U. S. DEPARTMENT OF TRANSPORTATION  
FEDERAL AVIATION ADMINISTRATION

6340.27 CHG 5
------------------

12/4/1998

RADAR FACILITIES AND EQUIPMENT MODIFICATION HANDBOOK -  
SUBJ: AIR ROUTE SURVEILLANCE RADAR, ARSR-4

Figure 7-9. Array Bulkhead Cables and Input/Output Connections

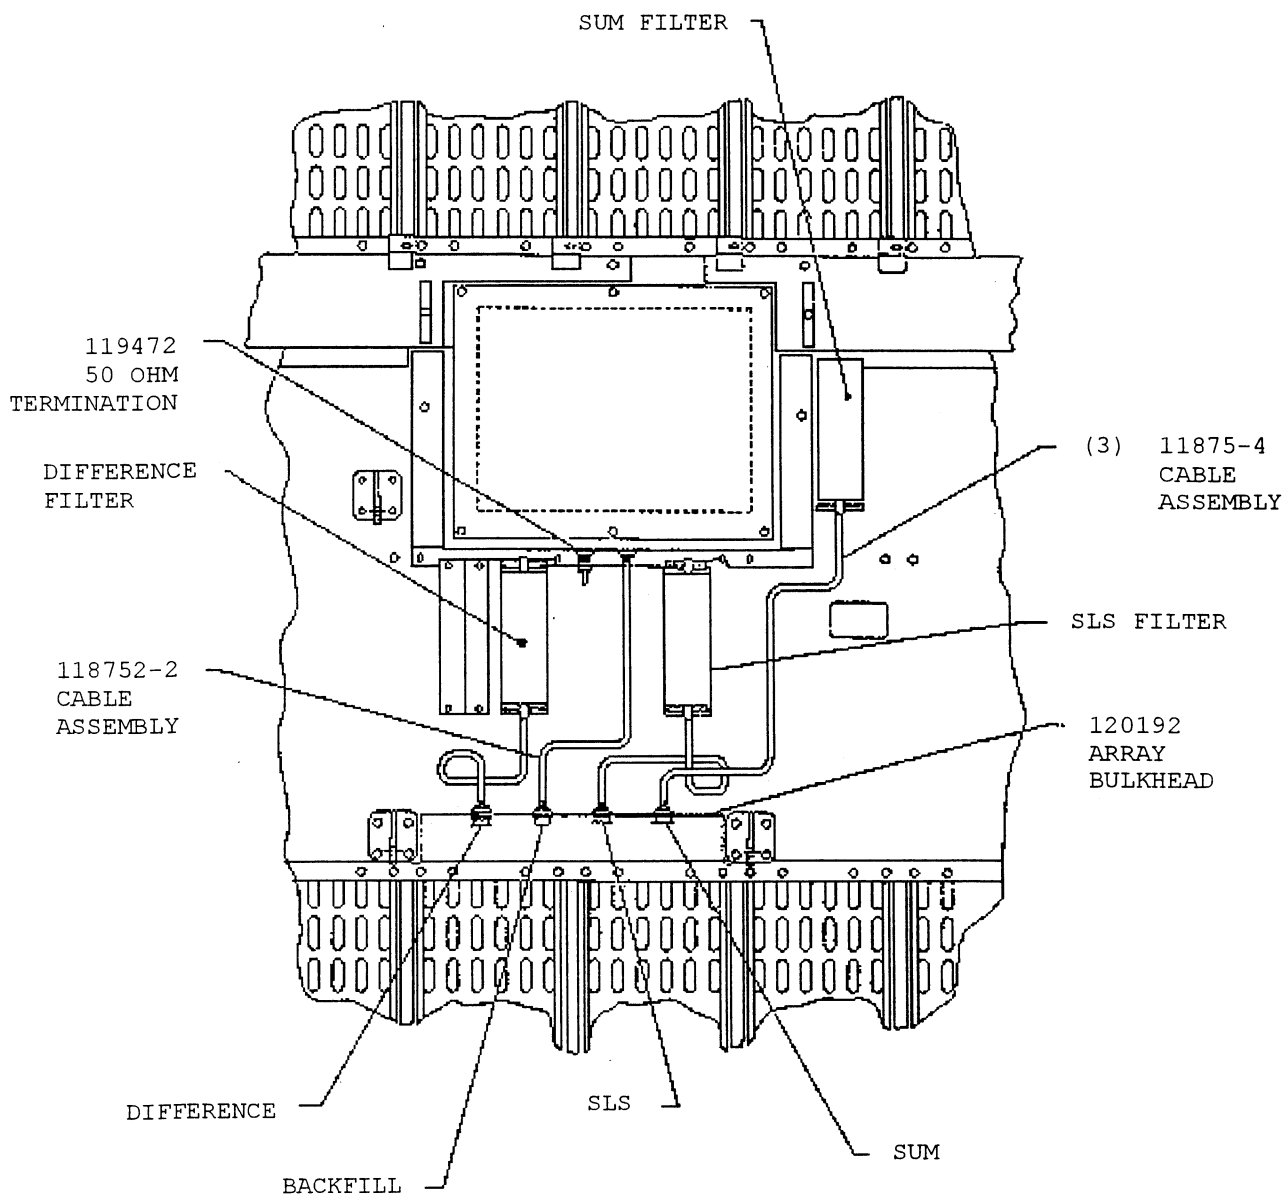
- (1) Turn off the interrogator of both channels of the ATCBI-5.
- (2) Access radome area in accordance with TI 6340.30, paragraph 3.4.1.1.
- (3) Disconnect SLS port cable, W51, from the SLS Filter using A-N Connector Pliers, see TI 6360.95, Figure 7-9, Array Bulkhead Cables and Input/Output Connections.

- (4) Using a 11/16-inch wrench disconnect cable W63 from the Array Bulkhead, see TI 6360.95, figure 7-9.
- (5) Using a  $\frac{3}{4}$ -inch wrench disconnect cable W51 from the Array Bulkhead, see TI 6360.95, figure 7-9. Retain W51 in spares inventory. W51 will be required when the Air Traffic Control Beacon Interrogator Model 6, ATCBI-6, is fielded.

- (6) Using a  $\frac{3}{4}$ -inch wrench connect N-Type Female Bulkhead (item 7c) to SMA Male Adapter provided in modification kit, (item 7a) to the Array Bulkhead, see TI 6360.95, figure 7-9.

- (7) Using a 11/16-inch wrench connect cable W63 to the Array Bulkhead, see TI 6360.95, figure 7-9.
- (8) Using a torque wrench connect input to 3 dB splitter (item 7b) provided in modification kit to the N-Type Female Bulkhead to SMA Male Adapter in step 6.

- (10) Using A-N Connector Pliers disconnect cable Difference Port Cable W52 or 50 ohm termination, depending on site configuration, from Difference filter, see TI 6360.95, figure 7-9.

Figure 7-9A. Array Bulkhead Cables and Input/Output Connections for ARSR-4 with ATCBI-5

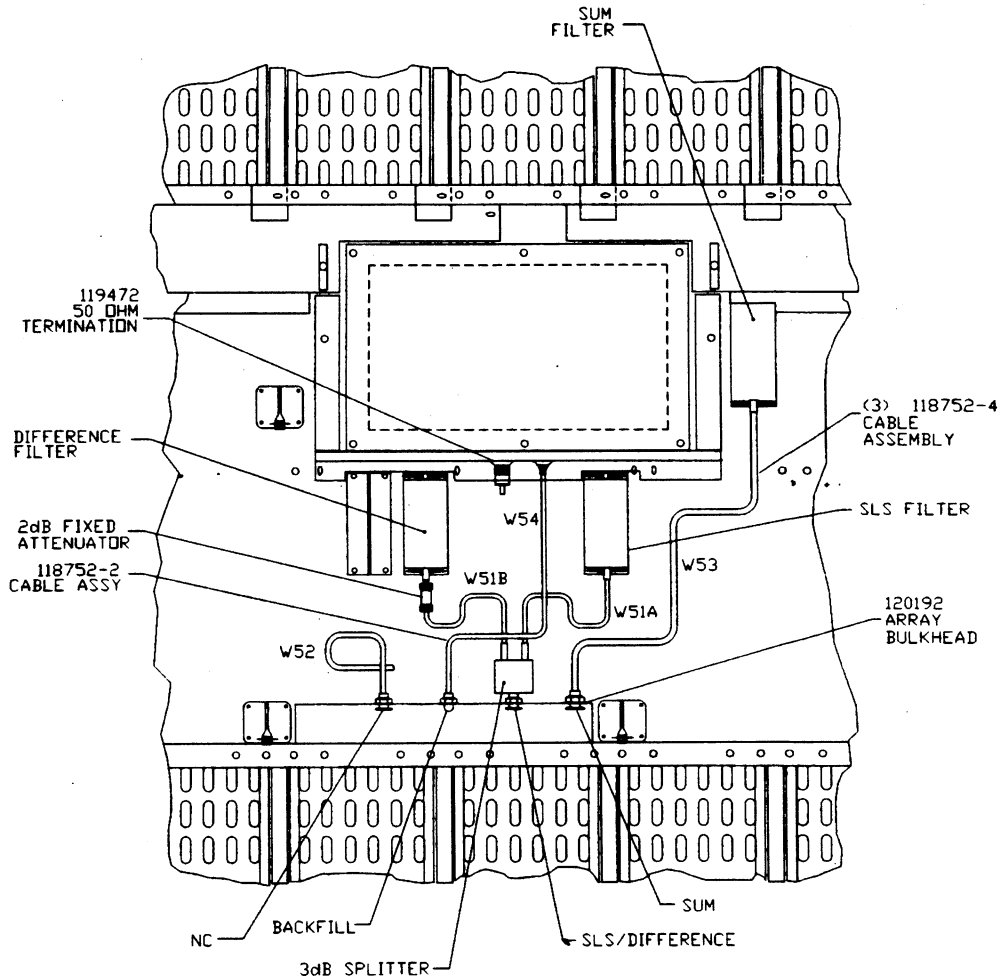
- (9) Using torque wrench connect cable SLS Port Cable W51A (item 7e) to right output of 3 dB splitter in step 8 and SLS Filter using an A-N Connector Pliers, see TI 6360.95, figure 7-9A.

- (11) Using A-N Connector Pliers connect 2 dB fixed attenuator, (item 7d) to difference filter, see TI 6360.95, figure 7-9A.
- (12) Using torque wrench connect cable Difference Port Cable W51B (item 7f) to left output of 3 dB splitter in step 8 and Difference Filter using A-N Connector Pliers, see TI 6360.95 figure 7-9A.

- 6A16W51A Cable Assembly (3 dB Splitter to SLS filter)
- 6A16W51B Cable Assembly (3 dB Splitter to 2 dB Fixed Attenuator)
- 6A16AT1 2 dB Fixed Attenuator
- 6A16A1 3 dB Splitter
